Staff Report – Planning & Zoning Item

Date: April 19, 2016
Case No.: Z-16-04
Request: AG to PD-C-1
Applicant: Nilay Limbachiya

Z-16-04 Hold a public hearing and consider a zoning change from Agricultural to Planned Development Commercial-1 Zoning District for a recreational vehicle park on a 20 acre tract of land, located on the east side of South Interstate Highway 35, south of Grove Road.

Project: Hubbard Branch Phase I, Final Plat and Construction Plans

SHEET TITLE: OVERALL ROADWAY & SIDEWALK LAYOUT

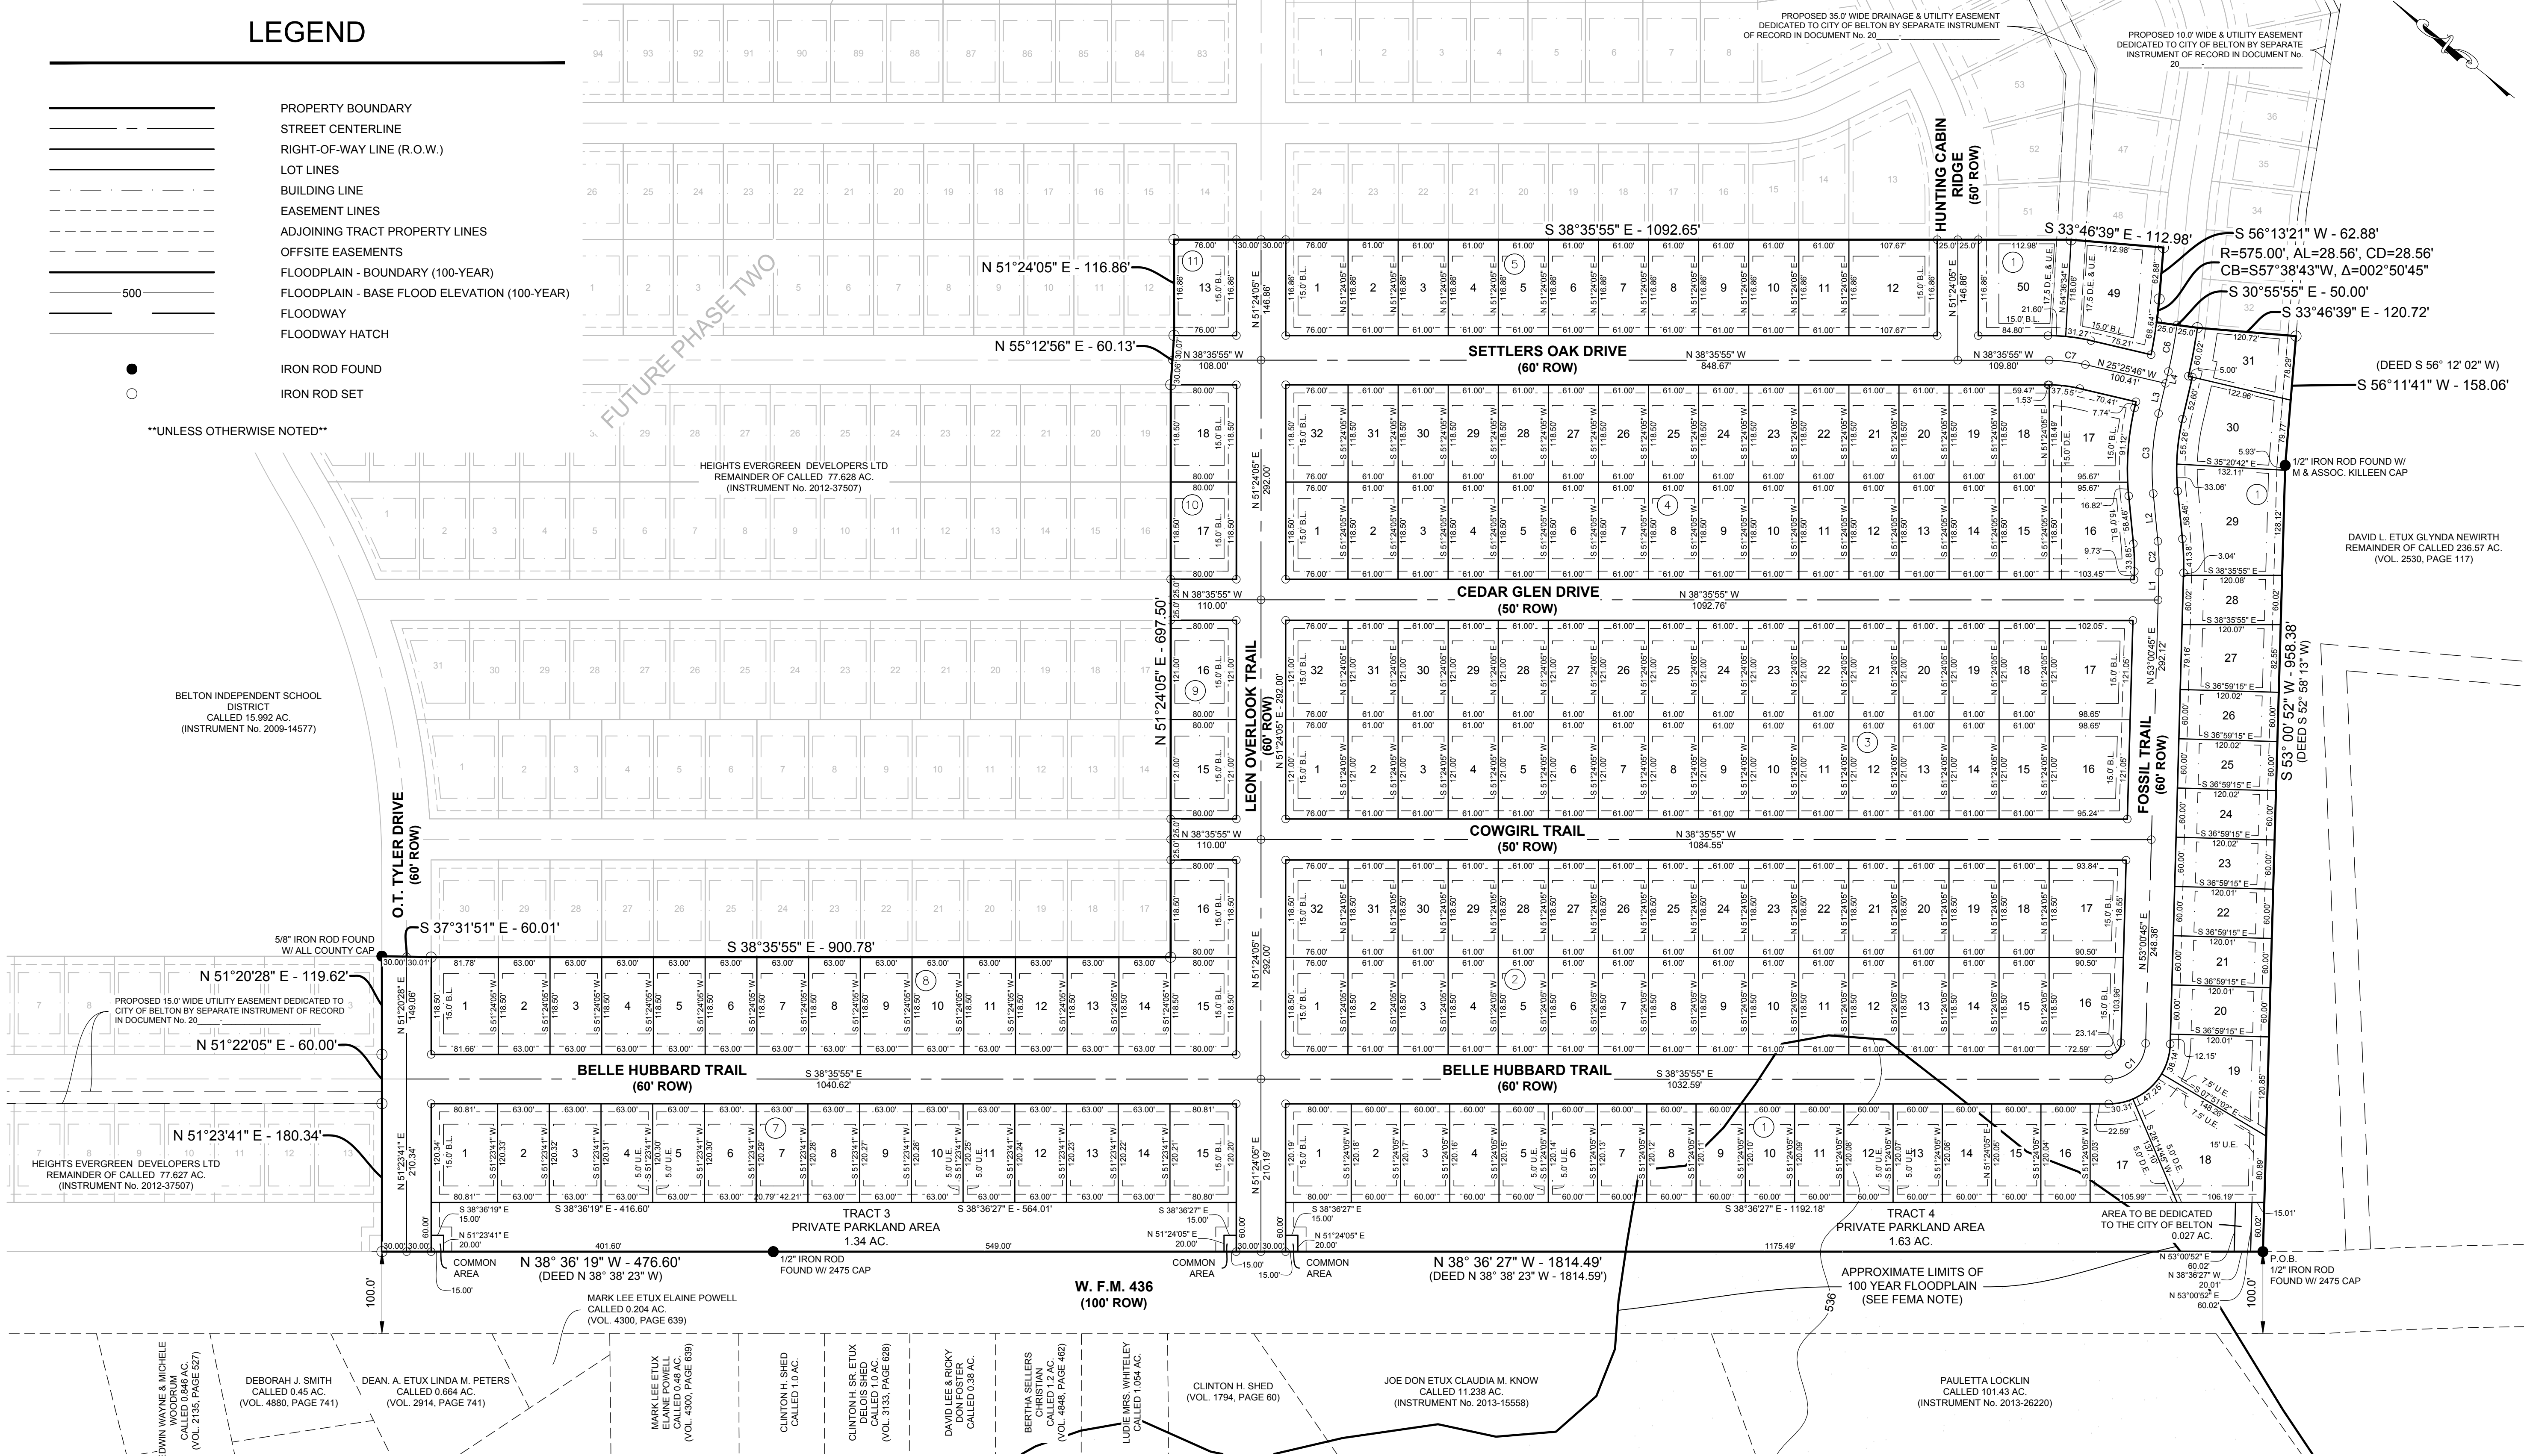
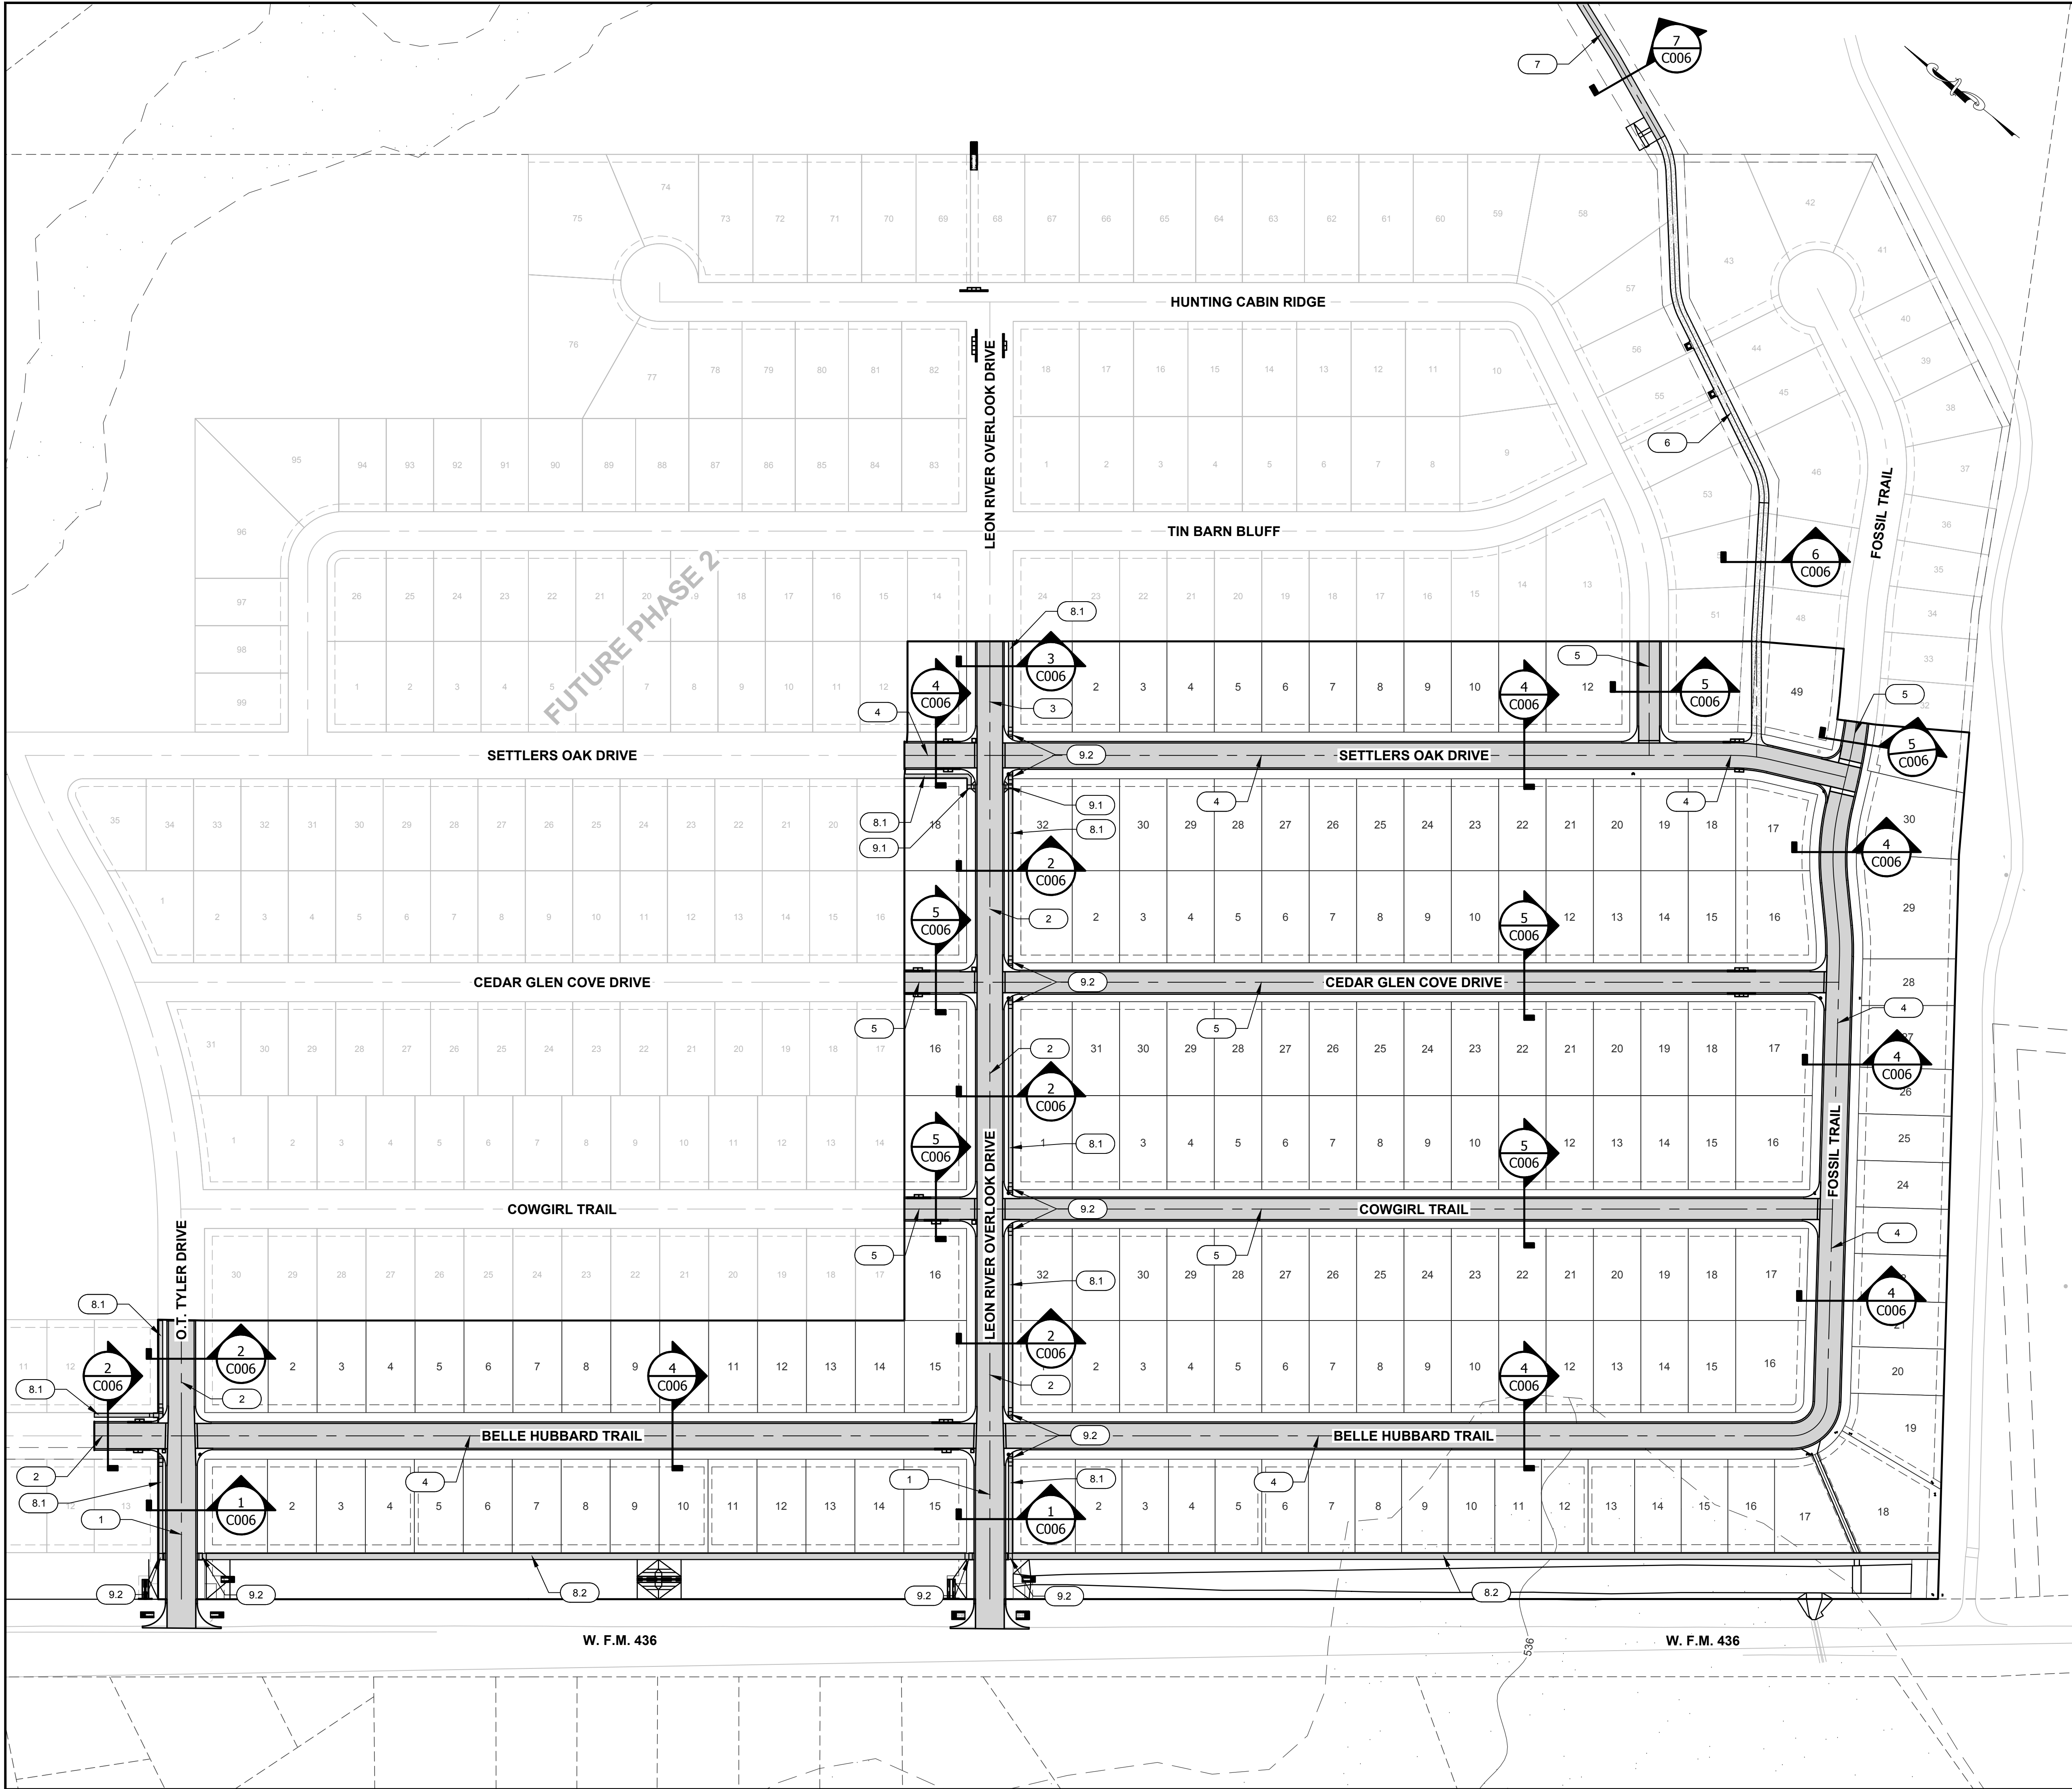
3. Please submit a revised exhibit, prior to the P&ZC and Council meetings that identifies the collector streets and sidewalks, as was done previously for the parkland exhibit.

4. There are 177 lots in Phase 1; therefore, the parkland fee is \$35,400. Please submit this payment prior to construction plan approval.
5. Awaiting TXDOT response regarding the TIA and ROW of FM 436.

6. The fencing along FM 436 (arterial roadway) is required have masonry columns spaced every 50 feet with wood fencing with a capped topped rail.
7. Sheet C002 is blank.

8. The street lights are spaced too close together. Please revise to be 300 linear feet apart. A recommended street lighting plan is attached.
9. Please state the trees proposed to be preserved and removed on the tree survey (Sheet C011).

1. General
 - a. Cover: Change contacts from PWD and Water Superintendent to City Engineer, Angellia Points, P.E. and Construction Inspector, Rick Hairston.
 - b. C001 Index. Reference links are broken.
 - c. C002. Blank sheet. C002 was references in the comment responses.
 - d. C003. Global change throughout plans. Change Note 1 to the satisfaction of the "City Engineer" in accordance...
 - e. C003. Note 22. Utility permits in FM436 ROW will be from TxDOT.
 - f. C003. Note 41. Street design shall be approved by the City of Belton.
 - g. C003. Note 14. State "domestic USA" products.
 - h. C003. Note 14.1. Add all BMPs shall be in place prior to any excavation.

- c. Provide a street signage and street striping plan per discussions regarding traffic control.
 - d. Base material is specified as TxDOT Type 248 and 347. Specify TxDOT Type 247 Type A, Grade 2 or better.

- e. Sheet C700 – In the Temporary Turnaround Detail, it says a Professional Engineer will determine the thickness of the base material. Please include the thickness details in the plans rather than wait until construction.

- f. Sheets C301-C303 – There are section labels for the lift station access road called A.1 and B.1, but there is no sheet reference as to where these sections can be found. It appears that these would correspond to Sections 7 and 6, respectively, on Sheet C006. This discrepancy needs to be corrected and a sheet reference added on Sheets C301-C303.

- g. C006. For clarity, add labels for what roads are covered by each section. Add details for strength of concretes, HMAC Type C OR D.
 - h. Consider dedicating the ROW and easements for future phases of Hubbard Branch. Doing so allows eliminated the need for intermediate easements. It also ensures utilities to be placed at the proper bury depths and alignment of non-Phase I utilities. Along those same lines, consider setting top of curb stakes for the non-Phase I utilities to allow for proper bury depths and alignments.

- b. C007. Add a 12" valve at connection to existing main. Show also on C201.
 - c. C007. Install a flush assembly at the end of the waterline at hydrant at FM436 on the southern corner of the property.

- d. C007. Identify the document number on the 15' utility easement when established.
- e. C007. Water Note 11. Change to domestic USA. Delete note 14.
- f. C008. Is the sewer flow directional arrow on the 10" sewer at Lot 49 correct? How is Lot 18 served by sewer?

- g. Recommend listing fire hydrant fittings required for project bidding clarification.
- h. Note ALL flush assemblies shall be automatic.
- i. Some automatic flush assemblies are called out to be 8 inches. AFA are not produced at this size. Reduce to 2 inches. Revised recommended detail is attached.

- j. C209 through C212. Show 42" of cover from top of curb elevations at all locations in lieu of existing surface.
- k. Confirm sewer depths and sizes allow for subsequent phases to be built, including the school, and be able to gravity flow into the proposed sewer system.

- t. A 5' diameter manhole is not shown at lift station per 11-6-15 response.
- u. C306. As discussed, show flowable fill backfill under valve vault to ensure there is no future settling of structure. Use 1" crushed and washed gravel under wet well.

- h. C428. Use concrete 'square' dissipaters per COB detail, not curb stops.
- i. The top of weirs were set at the 100-year storm WSEs. With no freeboard and potentially high velocities, the entire width of the top of weirs should be concrete armored to prevent eroding the soils around the weir walls.

- o. Sheets C427-C429 – All concrete structures for detention outlets need to have the edges toed-in at least 18-inches. Currently, some details show a 2.50' toe (which is good), others show no toe at all.

- p. Sheet C403 – The details indicate that there are multiple ponds, yet there is only Detention Pond #3 labeled on this sheet. All ponds need to be labeled.

- s. Recommend the engineer call out the actual limits of pipe materials in the plan and profile where each type of proposed pipe is to be used, rather than leave it up to the contractor to determine this. RCP is required for stormwater pipe.
